## **SUPPLEMENTAL RESPONSE TO REQUEST FOR ADDITIONAL INFORMATION**

### **APR1400 Design Certification**

**RAI No.:** 274-8277

**SRP Section:** 07.01 – Instrumentation and Controls – Introduction

Figure 7.2-14 Plant Protection System Interface Logic Diagram for Division D

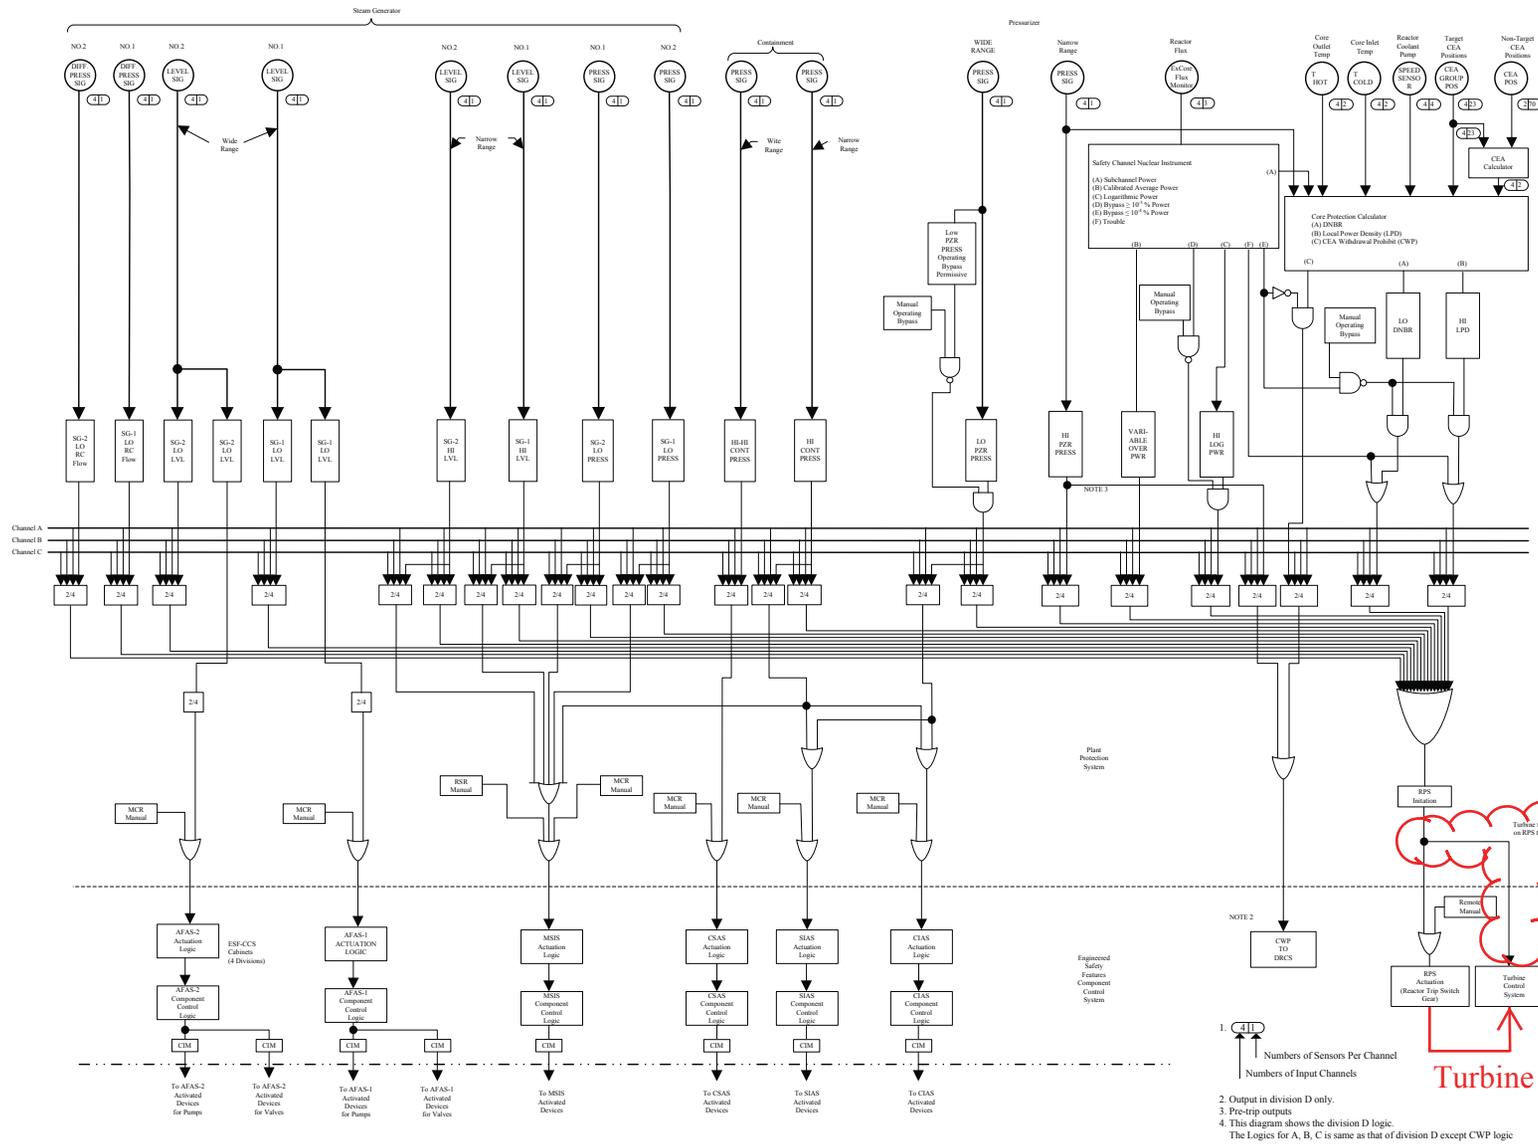
2. APR1400 FSAR Tier 2, Figure 7.2-14, only shows the PPS system interface logic diagram for Division D. It is unclear to the staff whether the interfaces depicted in this figure also apply to the other three PPS divisions. Clarify in the APR1400 FSAR whether this figure applies to the other PPS divisions. If there are differences between these interfaces for different divisions, provide a description of the differences in the APR1400 FSAR.

2. Notes 2 and 4 on the bottom right of Figure 7.2-14 are already provided. The notes indicate the figure applies to all PPS divisions except for the CWP implementation.
3. The "2-out-of-3 majority voting" logic stated in APR1400 FSAR, Tier 2, Section 10.2.2.3.3 is dedicated logic within the turbine control system (TCS) to generate the turbine trip signal during the system abnormal condition (e.g., generator stator wind coolant low flow, generator stator inlet water low pressure). This 2-out-of-3 voting logic does not use the signal from the 2-out-of-4 voting logic implemented in the plant protection system (PPS).

For turbine trip, each PPS division interfaces with the TCS as follows:

Two (2) sets of contact signals are provided per division in the reactor trip switchgear system (RTSS). A total of eight (8) output signals are generated. The contact signal, as a momentary signal type, is provided through hardwired connections. Isolation is achieved by using Class 1E isolation relays within the RTSS.

The two sets of contact signals from each division in the RTSS are inputted to two P-CCS cabinets through hardwired connections. The P-CCS cabinets have 2-out-of-4 voting logic to prevent spurious turbine trip due to single P-CCS cabinet failure. The results of the 2-out-of-4 voting logic in the P-CCS cabinets are provided to the TCS to initiate turbine trip.

Section 7.2.1.4 and Figure 7.2-14 of DCD Tier 2 will be revised to include the above information.
